AIRPORT LAND USE COMMISSION RIVERSIDE COUNTY AGENDA

STAFF REPORT

CASE NUMBER: ZAP1011BL16 – NRG Energy (NRG Renew DG Holdings, LLC) (Representative: James Kelly)

JURISDICTION CASE NO: CUP03728 (Conditional Use Permit No. 3728)

BLYTHE II SOLAR PROJECT	
WDID: 733C376130	GMP160067 BCR160089
SHEET CONTENT: POLE LOCATION EXHIBIT	
LOCATION: 1480 INVERBURY AVE BLYTHE, CA	
CLIENT: NEXTERA

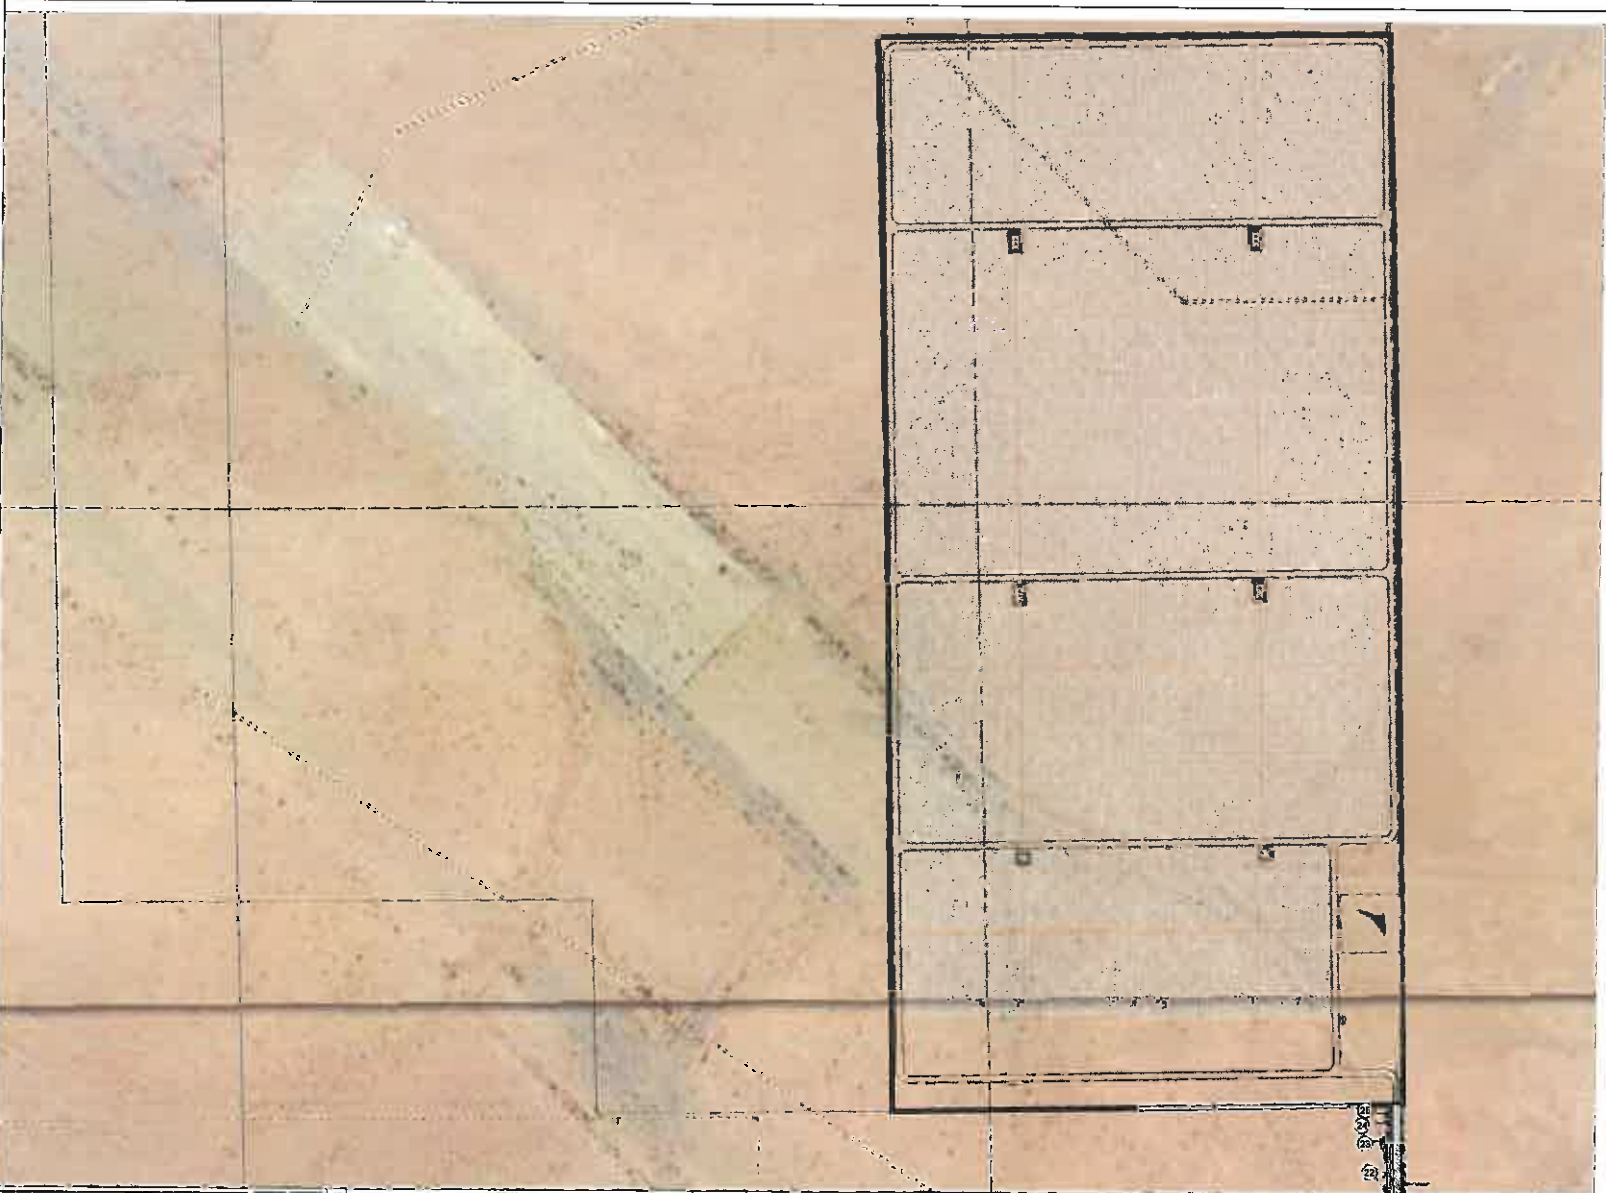
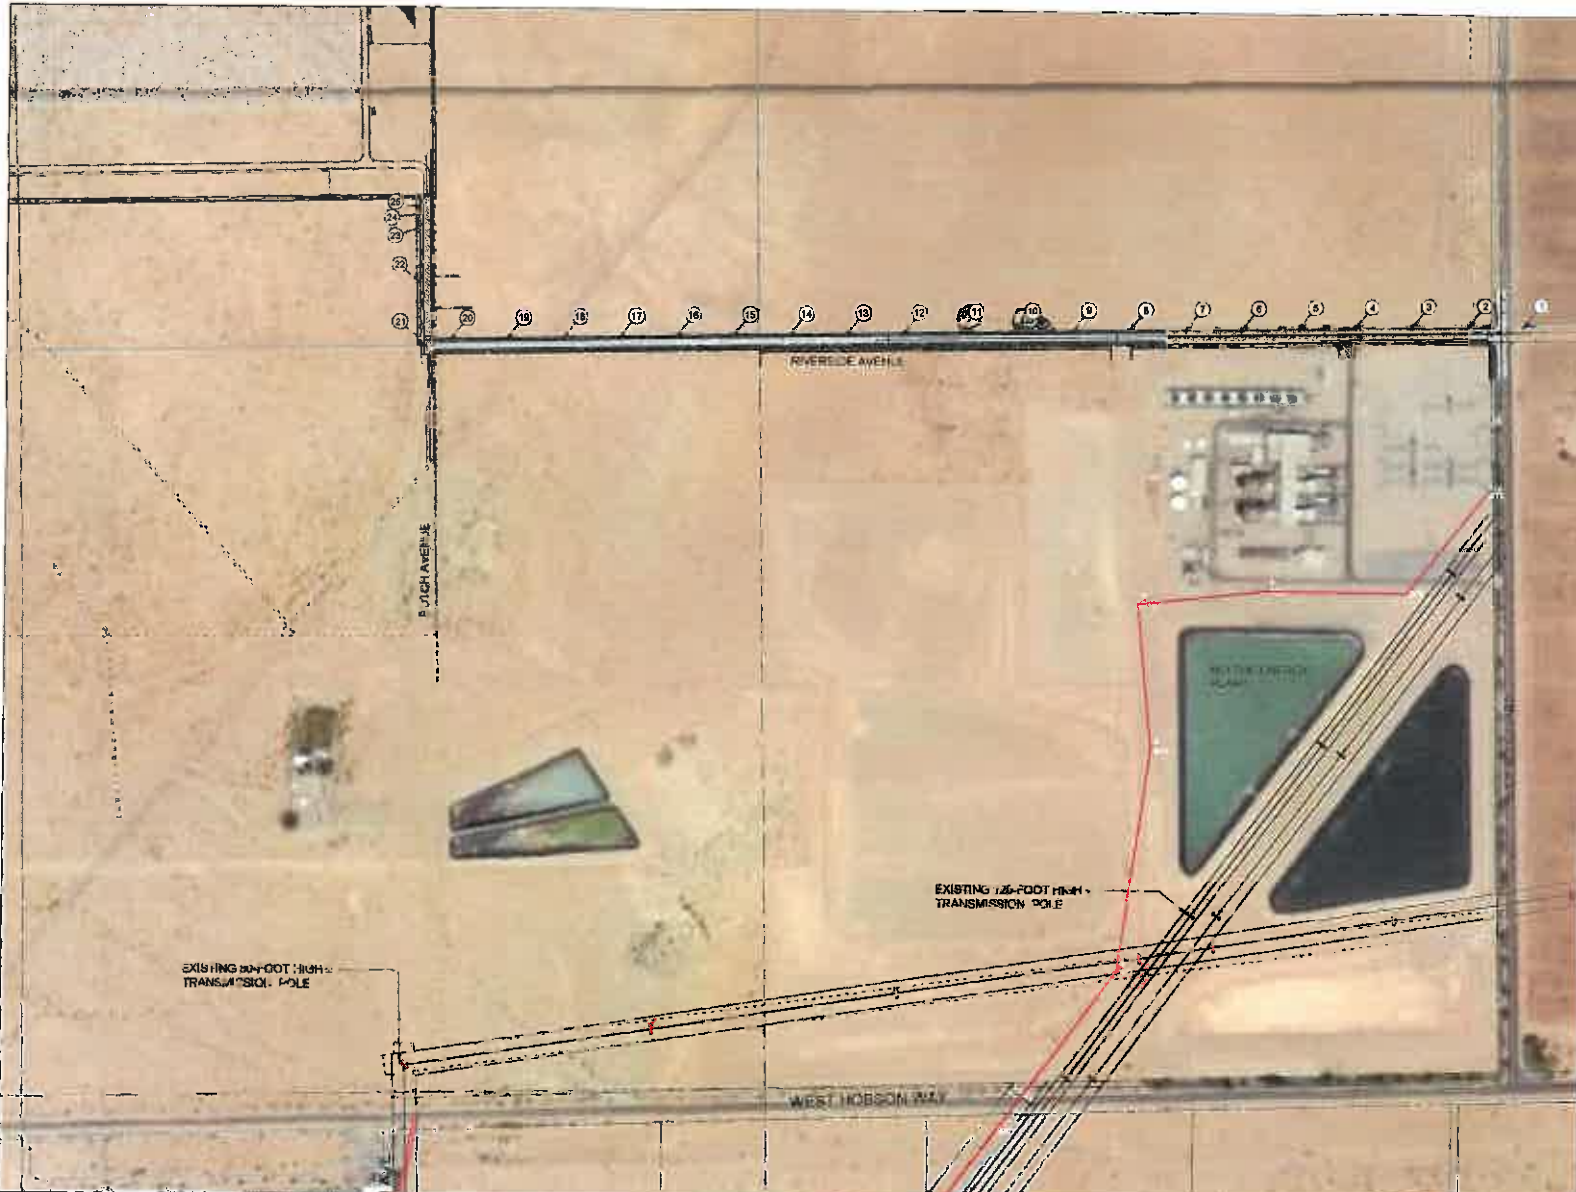
Part 77: The original applicant for ZAP1005BL09 had proposed 16 electric poles with a maximum height of 19 feet along a route extending directly south from the southeasterly corner of the project, with a maximum elevation of 416 feet above mean sea level at top point. Condition No. 9 limited the maximum height of the “transmission line towers/poles” to 19 feet above ground level and maximum elevation above mean sea level to 416 feet at top point. The original aeronautical studies by the Federal Aviation Administration Obstruction Evaluation Service were based on the initial proposed route of the original applicant. However, the source of the information that 19-foot poles would be workable for this project is not clear. The present applicant obtained “Determinations of No Hazard to Air Navigation” for 23 electric poles with a maximum height of 50 feet and a maximum elevation of 442 feet above mean sea level. Two additional poles at the easterly end of the line would have a maximum height of 51.5 feet.

Southern California Edison ("SCE") is the electric utility responsible for designing, constructing and owning the transmission line that connects the solar plant to the SCE electrical system. SCE has now completed their design for the above-ground transmission line. It still follows the route previously approved in ALUC's 2010 letter proceeding southerly along Butch Boulevard and then easterly along Riverside Avenue. However, the tower heights designed in accordance with SCE's system parameters exceed the 19 feet written in Condition 9, which was drafted prior to the towers being designed.

The towers as designed would not exceed 50 feet above ground level on Butch Blvd or most of Riverside Avenue. The FAA reviewed 23 tower locations at 50 feet above ground level along Butch Boulevard and Riverside Avenue and all of these locations received Determinations of No Hazard. There are two poles designed by SCE that would be 51.5 feet above ground level but they would be located at the eastern end of the line in an area where the ground elevation is approximately 50 feet lower than it is at the western part of the line. Therefore, these two poles would not exceed airspace height limitations and would be consistent with the Part 77 requirements for a Determination of No Hazard by FAA.

We therefore request that the language in this condition be amended to state the maximum height of the transmission line towers/poles shall not exceed 50 feet above ground level, unless approved by FAA as appropriate under a Determination of No Hazard.

Included for review and consideration are the Determinations of No Hazard from January 15, 2016. Also, included is an exhibit that shows existing transmission poles in this area and provides the context that the poles proposed for this project are shorter than many poles that already exist in this area.

Staff recommends that Condition No. 9 be amended to read as follows:

“The maximum height of the ~~transmission line~~ *electric line* towers/poles shall not exceed ~~nineteen (19)~~ *fifty (50)* feet above ground level, *except for two poles that may be up to 51.5 feet above ground level*, and the maximum elevation above mean sea level shall not exceed the elevations as referenced in Table 1 of the FAA letter dated ~~August 4, 2010~~ *January 15, 2016*. Such elevation shall not exceed ~~416~~ *442* feet above mean sea level.”

9. **The maximum height of the *electric transmission*-line towers/poles shall not exceed ~~nineteen (19)~~ *fifty (50)* feet above ground level, *except for two poles that may be up to 51.5 feet above ground level*, and the maximum elevation above mean sea level shall not exceed the elevations as referenced in Table 1 of the FAA letter dated ~~August 4, 2010~~ *January 15, 2016*. Such elevation shall not exceed ~~416~~ *442* feet above mean sea level.**

Figure 2
OCULAR HAZARD PLOT

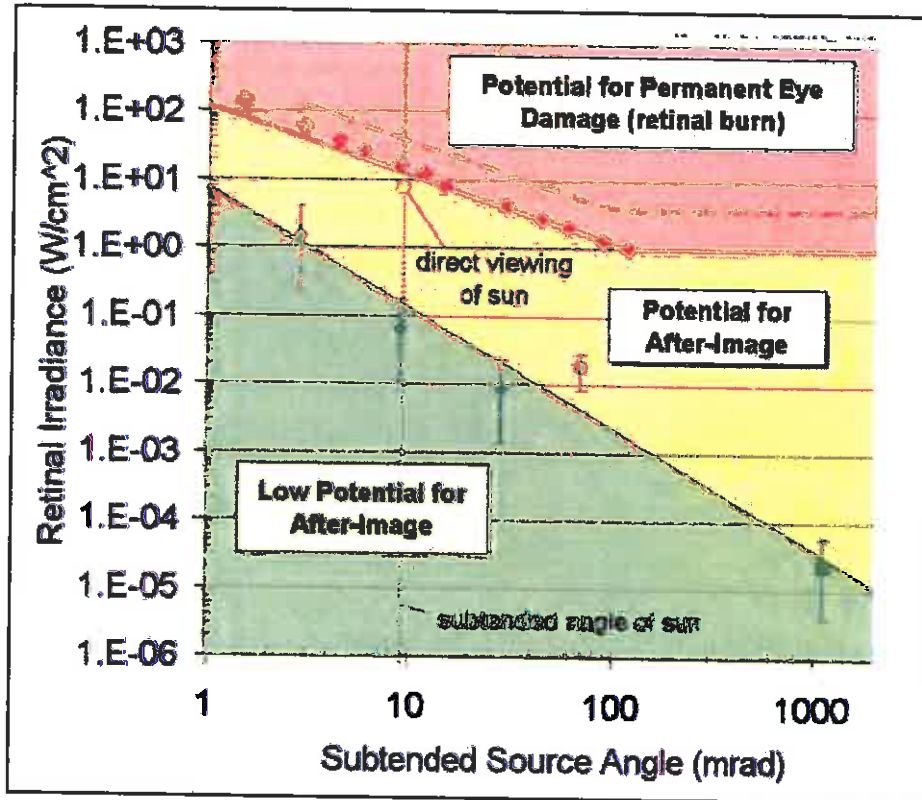
FAA adopted the *Solar Glare Hazard Analysis Plot* shown in **Figure 2** below as the standard for measuring the ocular impact of any proposed solar energy system on an airport under FAA jurisdiction. To obtain FAA approval, the airport sponsor and proponent are required to demonstrate that the proposed solar energy system meets the following standards:

1. There would be no potential for glint or glare in the existing or planned Airport Traffic Control Tower (ATCT) cab, and
2. There would be no potential for glare or “low potential for after-image” (shown in green in **Figure 2**) along the final approach path for any existing landing threshold or future landing thresholds (including any planned interim phases of the landing thresholds) as shown on the current FAA-approved Airport Layout Plan (ALP). The final approach path is defined as two (2) miles from fifty (50) feet above the landing threshold using a standard three (3) degree glidepath.
